LOUISIANA
POWER & LIGHT

W3P84-0709
Q-3-P43

SUBJECT: Waterford SES Unit 3
Docket No. 50-382
Request for Relief from Certain Technical Requirements of
Appendix R to 10CFR50

ENCLOSURE 1
EXCEPTIONS FROM THE
TECHNICAL REQUIREMENTS OF 10CFR50, APPENDIX R
FOR THE REACTOR AUXILIARY BUILDING

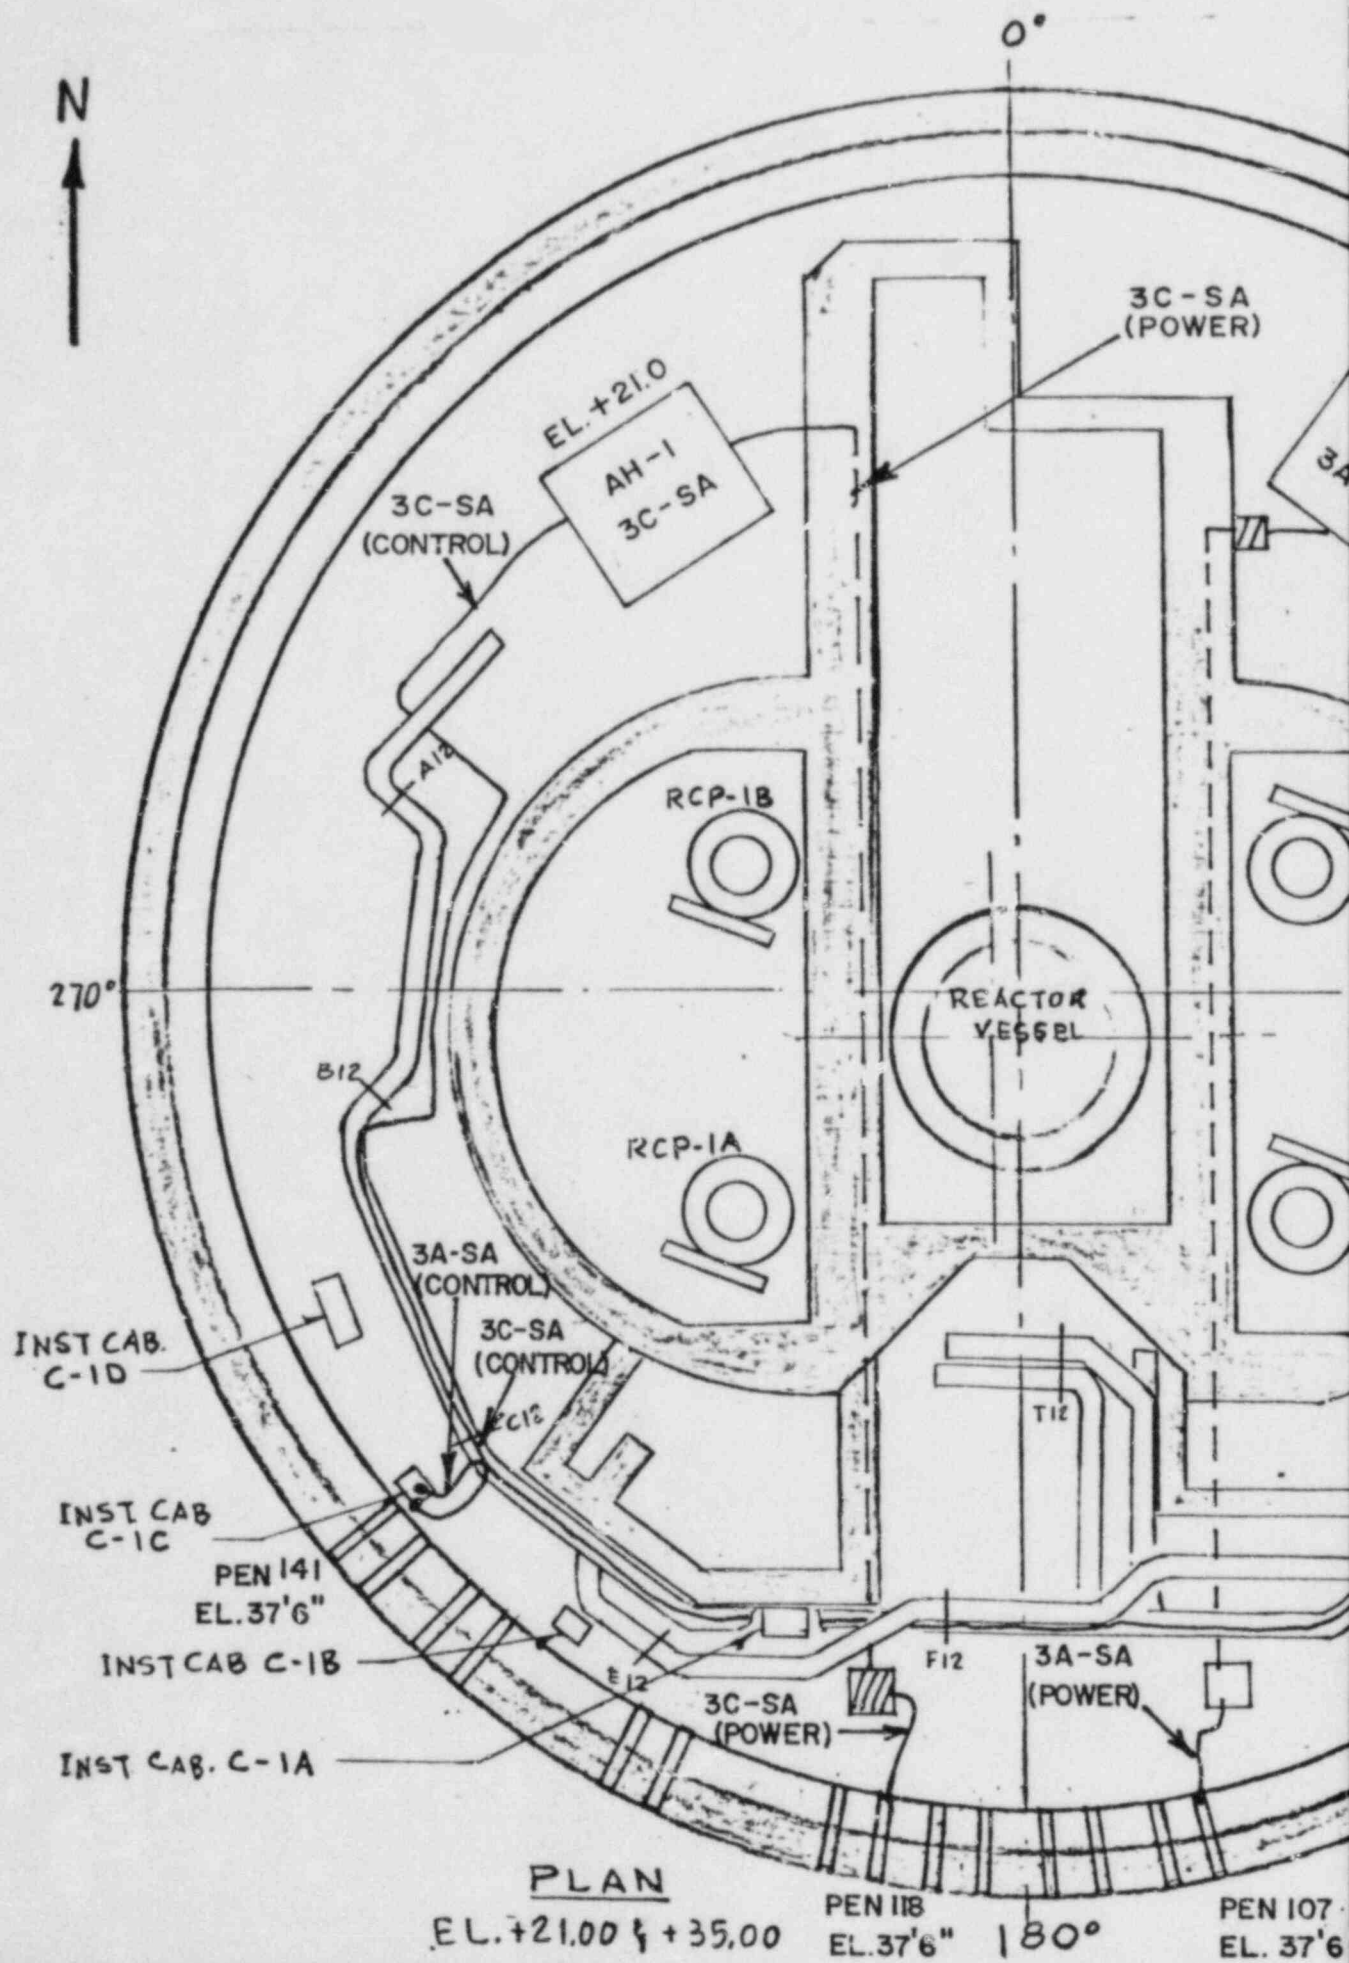
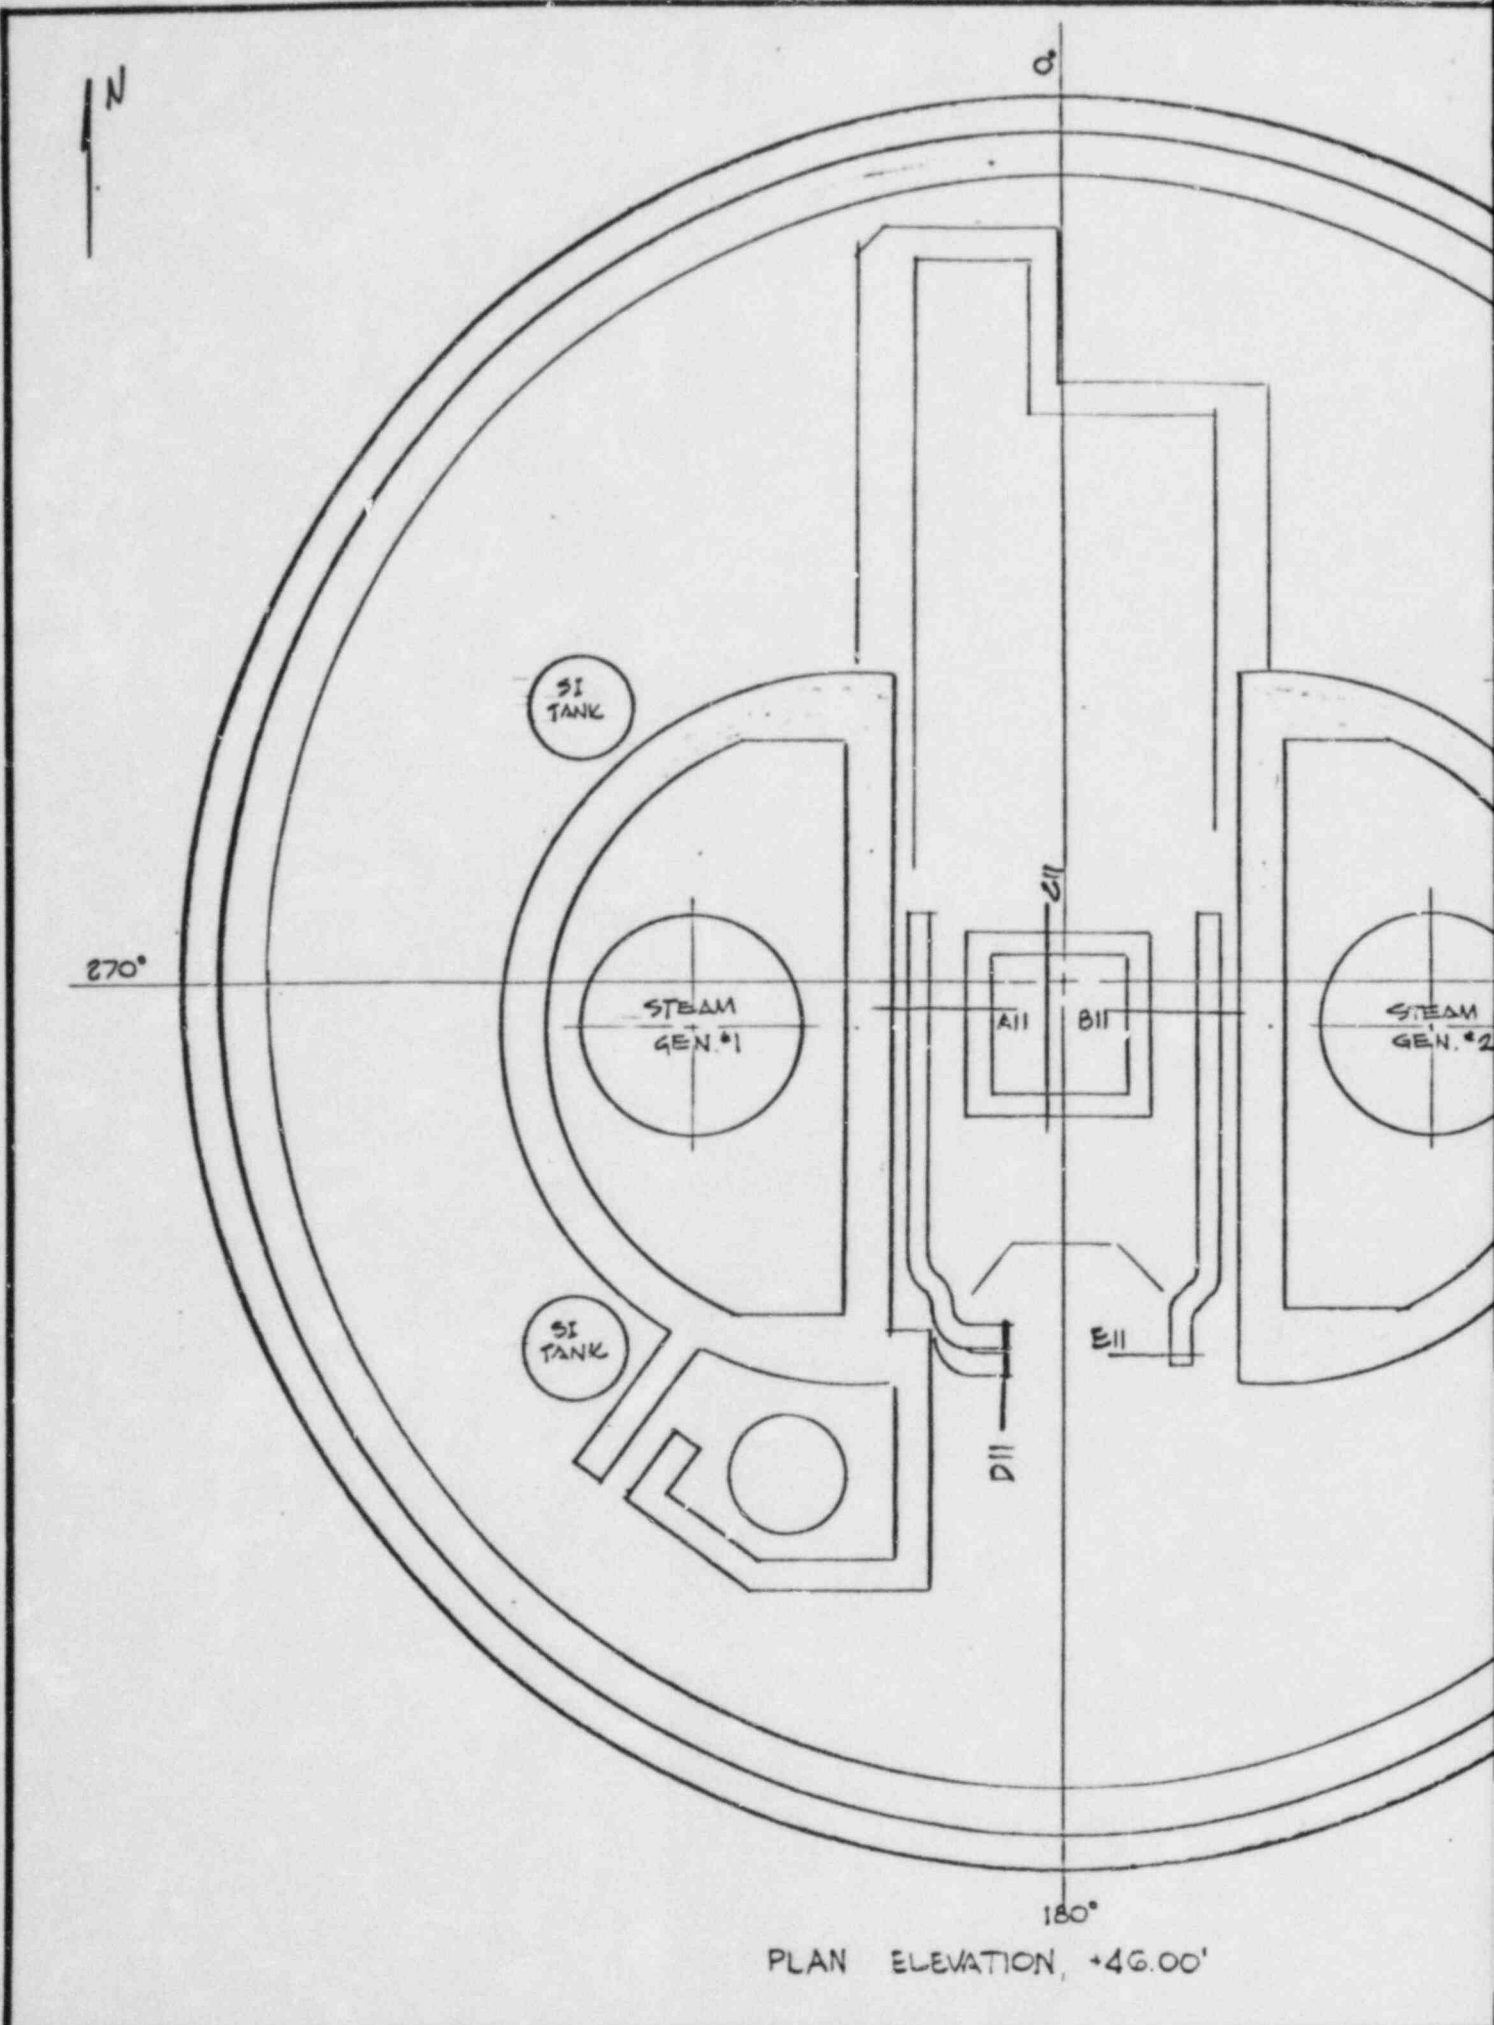
As can be seen on Figure III.H-2, the power cables from redundant divisions come no closer than at their electrical penetration area above the platform at Elevation +35.0. At this point, cables from units 3A-SA and 3B-SB are about 40 feet apart. The only intervening combustibles are the inboard banks of lightly loaded cable trays. As is apparent from Figure III.H-2, all four penetrations for the power cables are widely spaced.
